CURRENT FLOW ISSUE

Solflare

FLOW IF THE AMOUNT SPENT IS LESS THAN 38 BRL

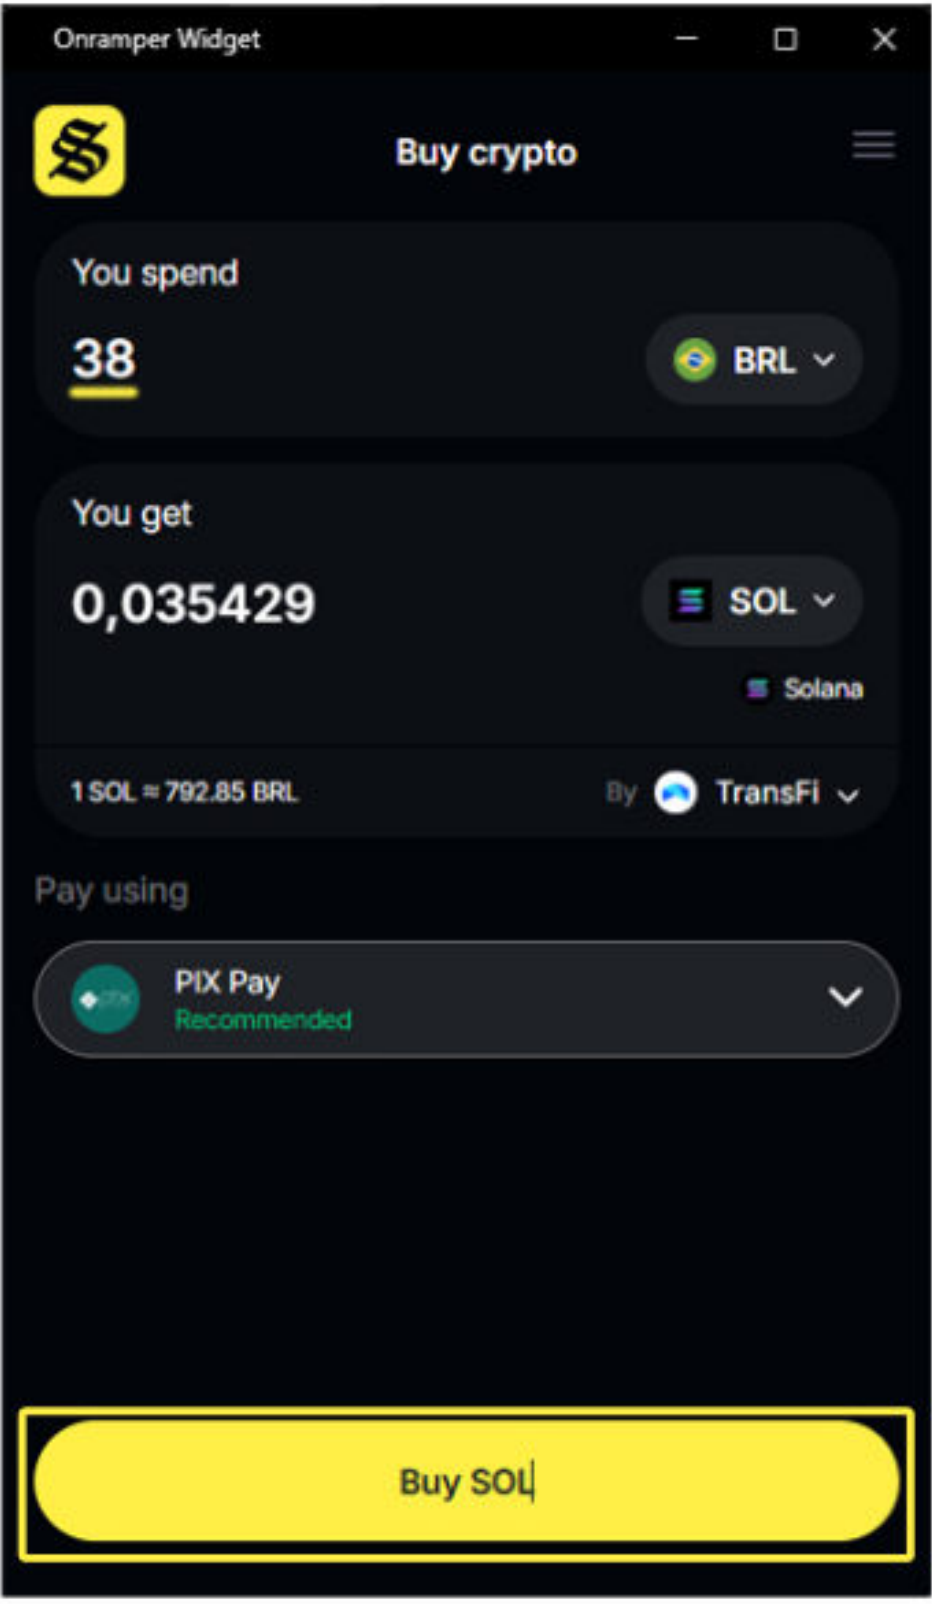
*The PIX Pay option remains highlighted as possible, but the purchase button remains inactive

FLOW IF THE AMOUNT SPENT IS LESS THAN 33,75 BRL

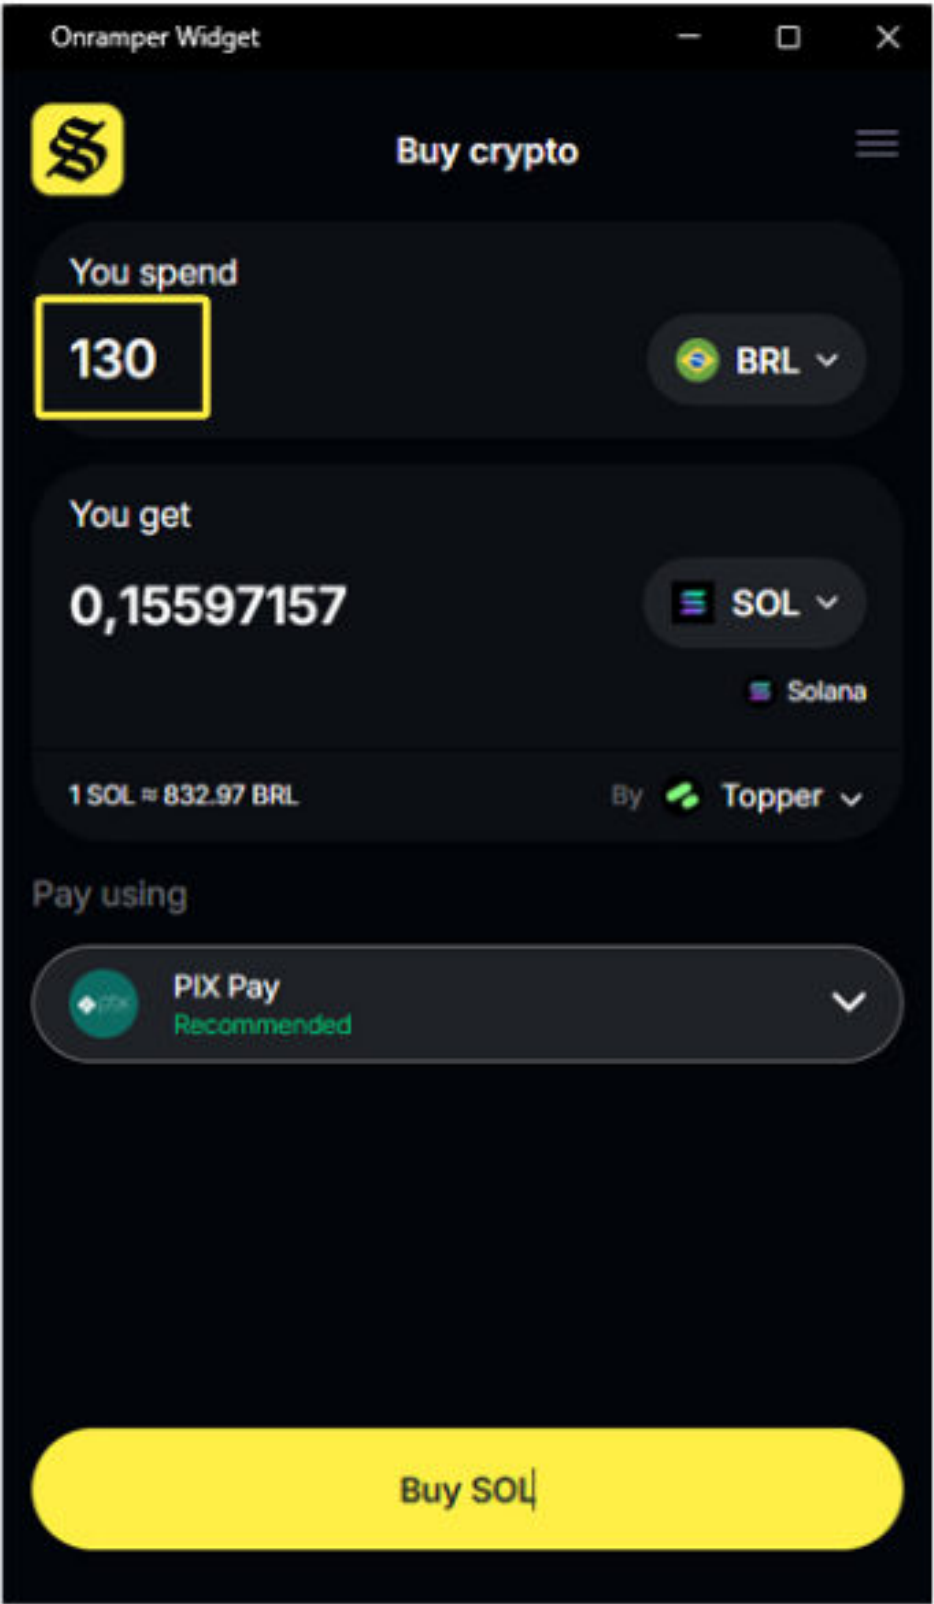
The average user might get frustrated here and get out of the flow, but I'm a designer

Let's go to the limit, test the new range

Now we can buy

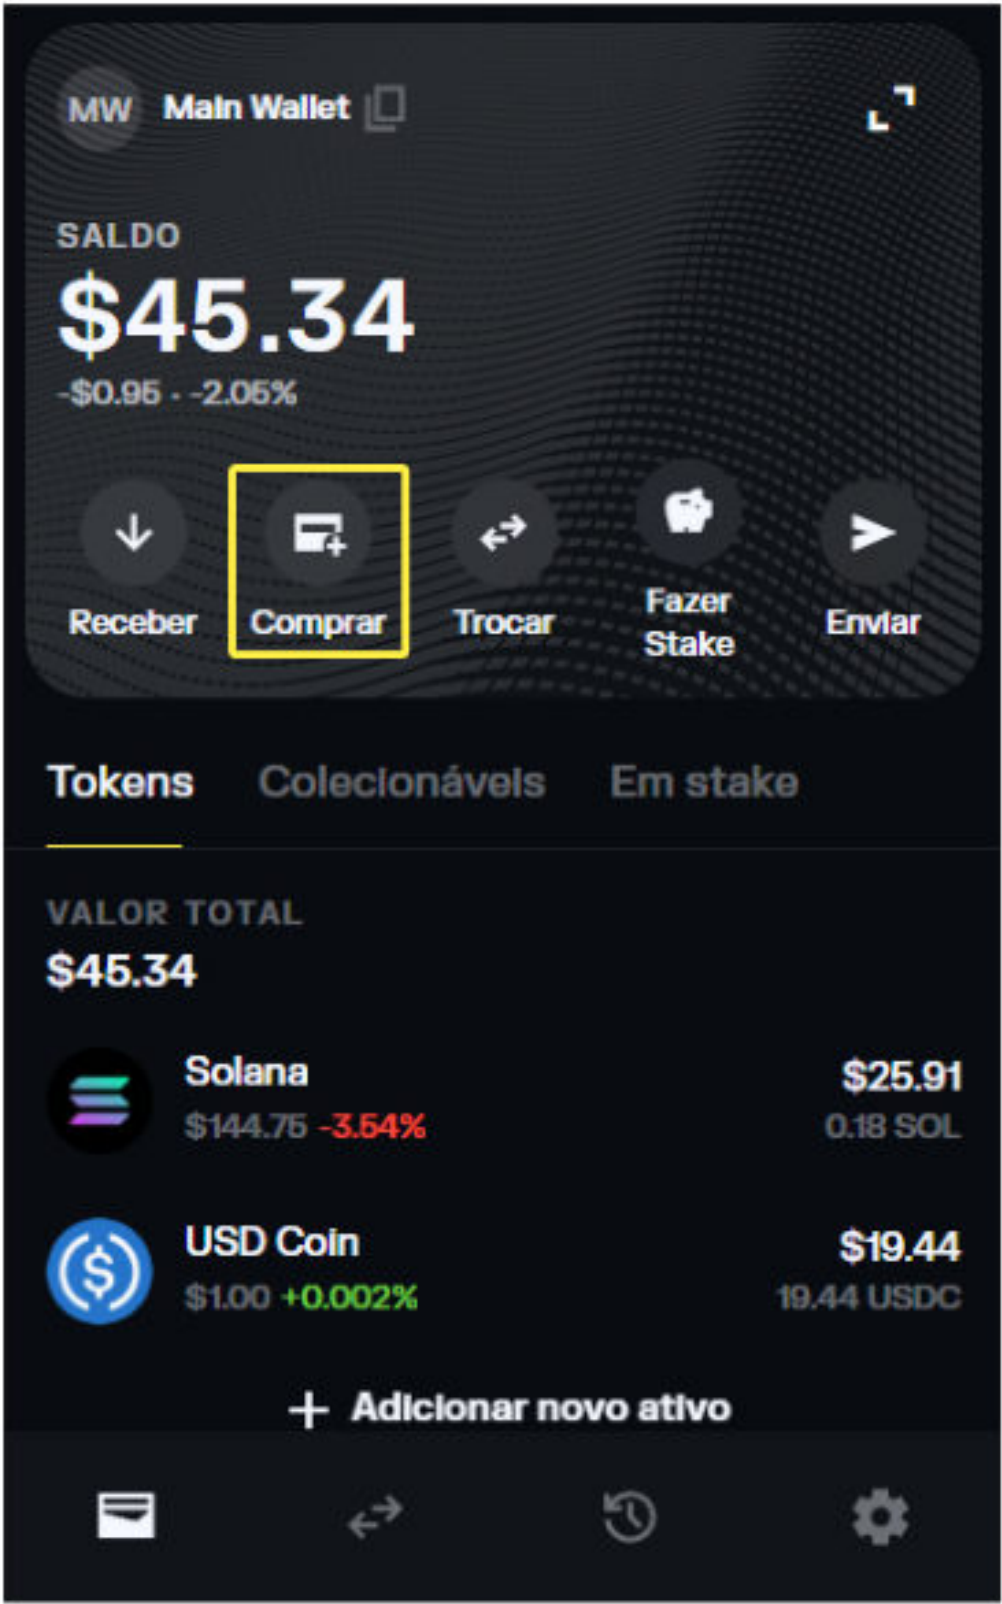
Addendum, from this point on: from 33.75 to 37 it continues to give feedback of at least 54.94

But what if we test the invisible range of 38+ again?

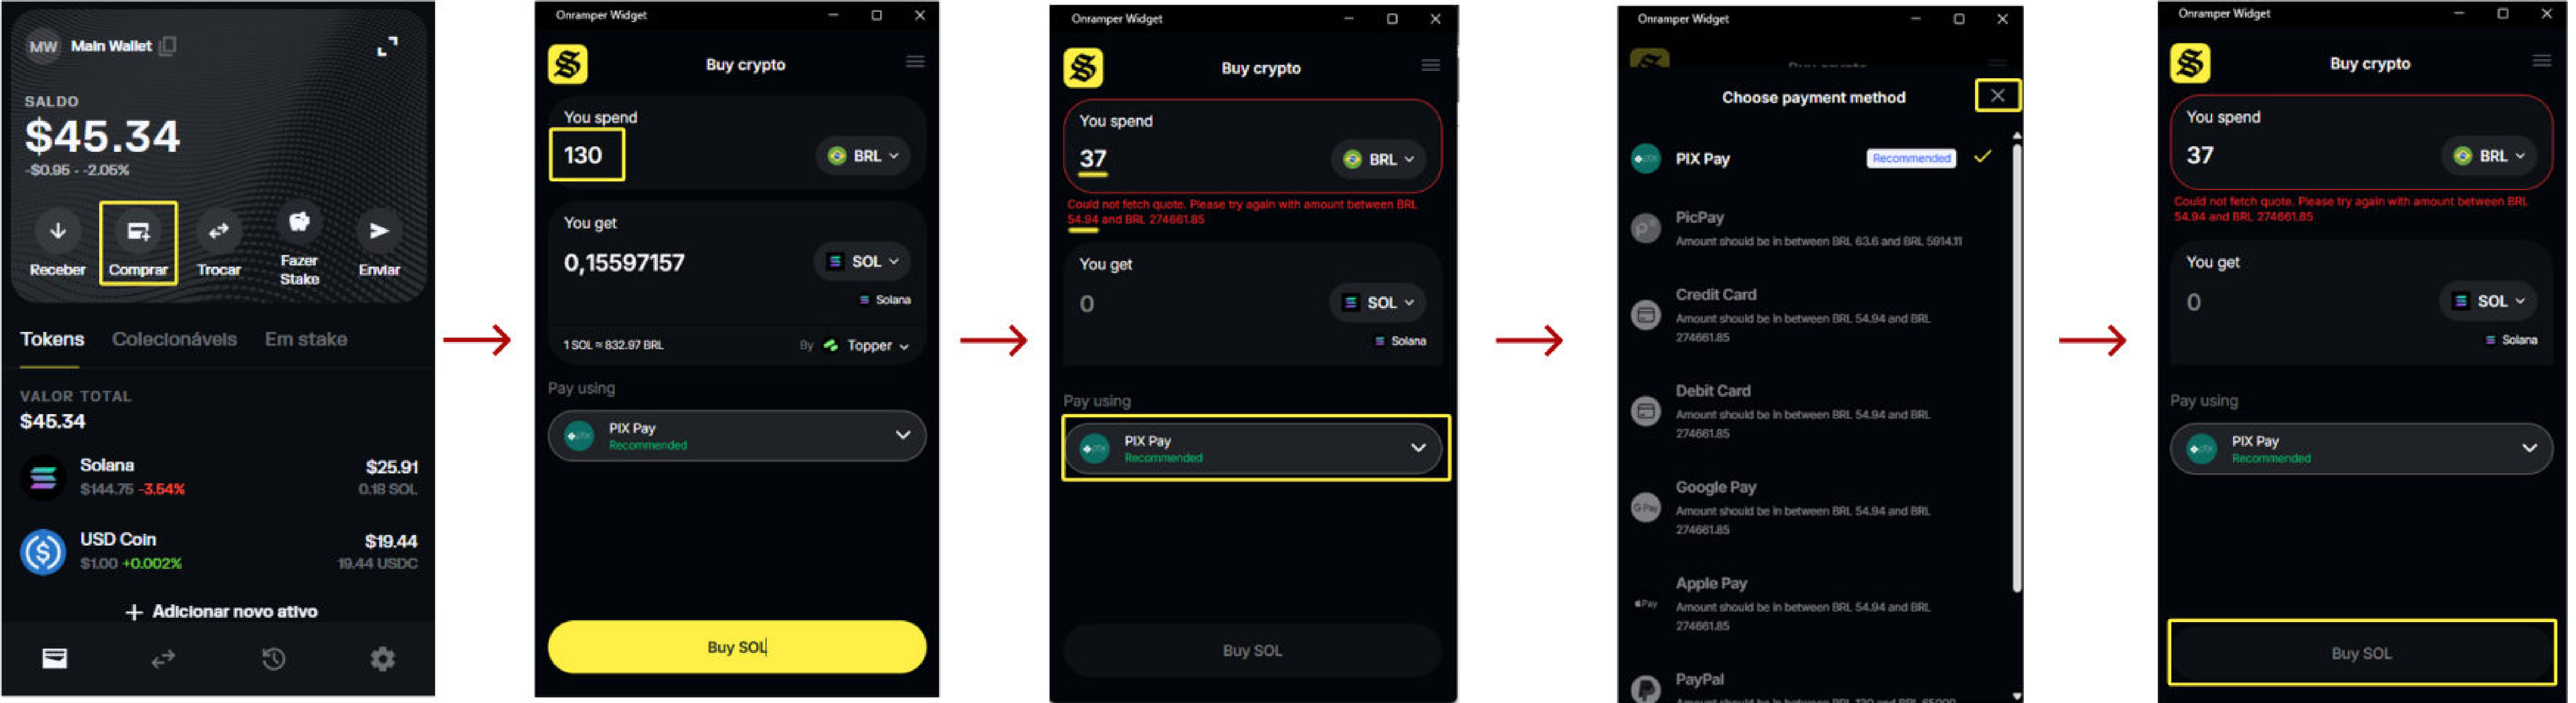
However, the current flow presents a **lack of feedback on minimum deposit values**.

- The PIX Pay option remains active.
- The purchase button stays inactive without explaining why.

→ **This creates confusion, erodes trust, and introduces friction in a flow that should be fast and transparent.**

The true minimum for PIX deposits is currently R\$38.00.

- Display the correct minimum deposit amount in real time.
- Either set it clearly at R\$38.00, or implement a dynamic value that adjusts to exchange rates and operator fees.
